Amendments to the Drawings:

REMARKS/ARGUMENTS

FIGURE 3

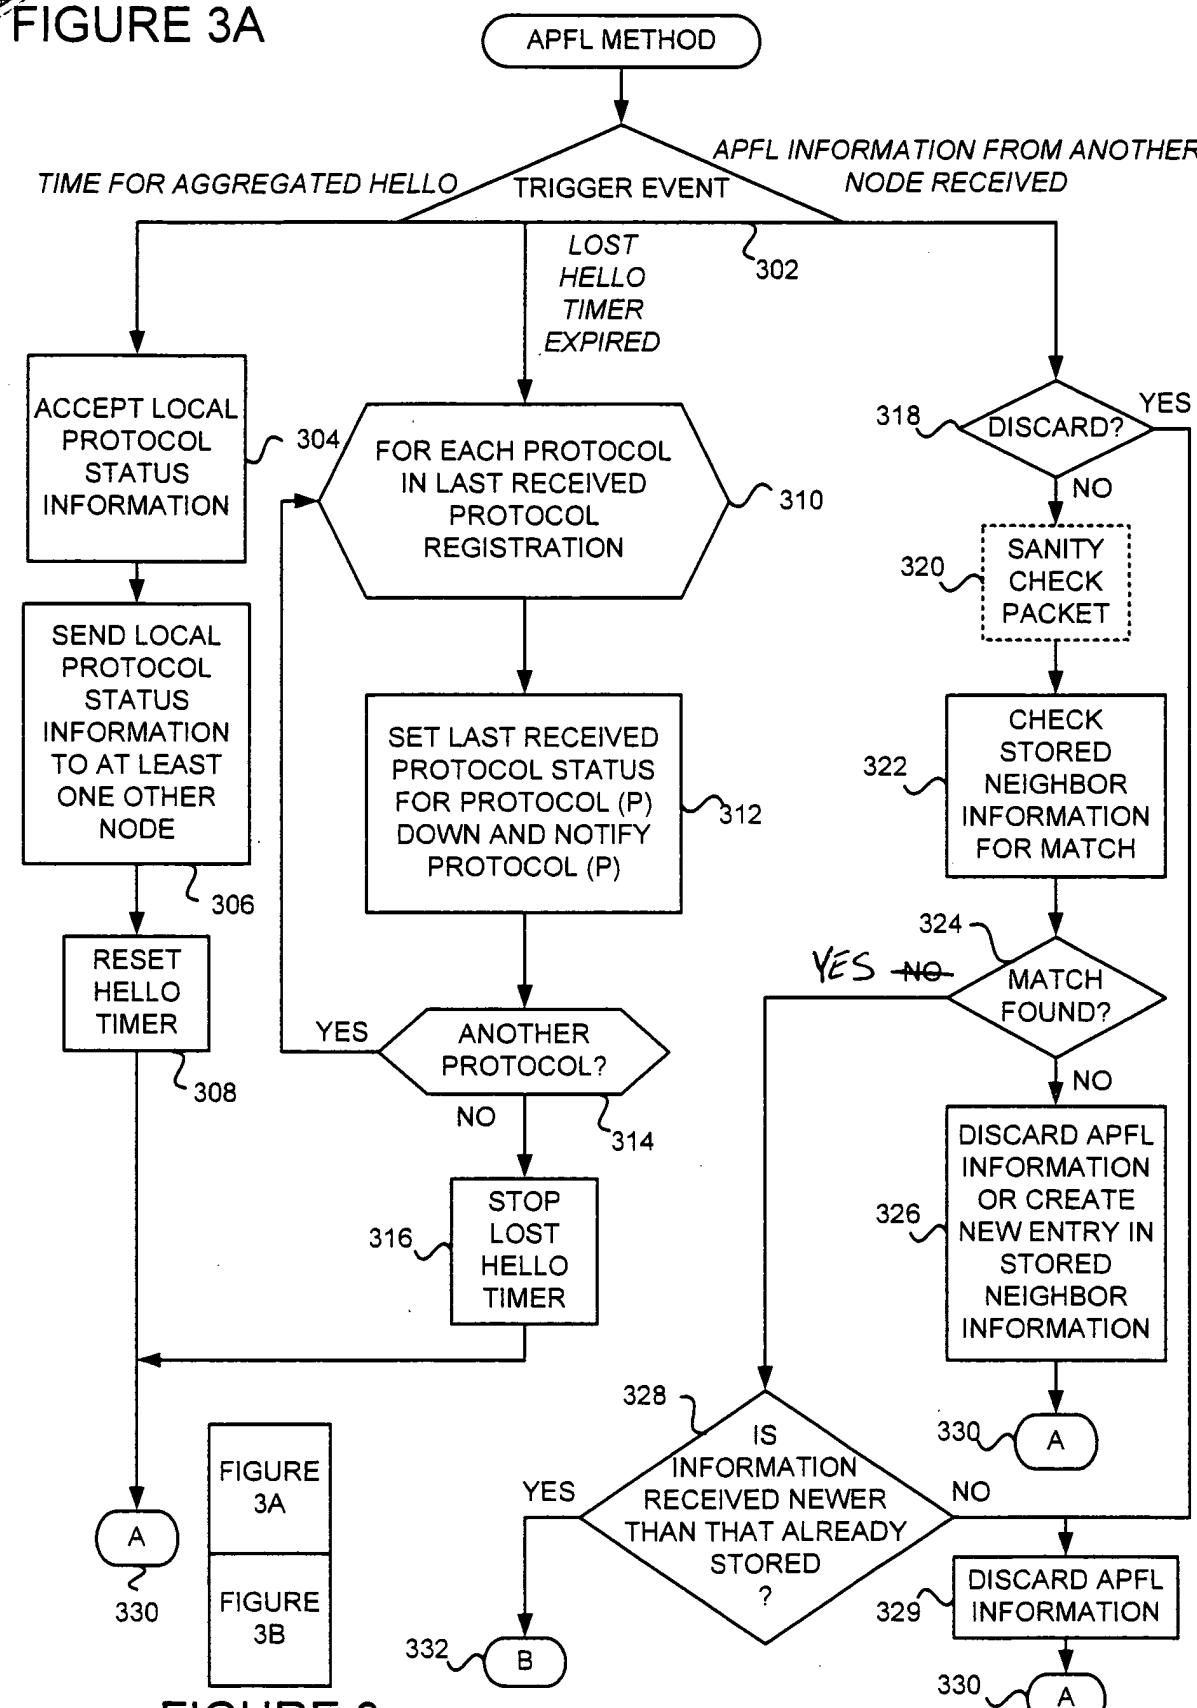
Figure 3 is objected to because the MATCH FOUND (324) test in Figure 3 results in different steps (326 and 328) in response to a NO answer. Figure 3 has been amended to correct this issue. The amendment is supported, for example, by paragraph [0034] of the specification. A corrected drawing sheet in accordance with 37 C.F.R. § 1.121(d) is filed herewith. Therefore, the applicant respectfully requests that this objection be withdrawn.
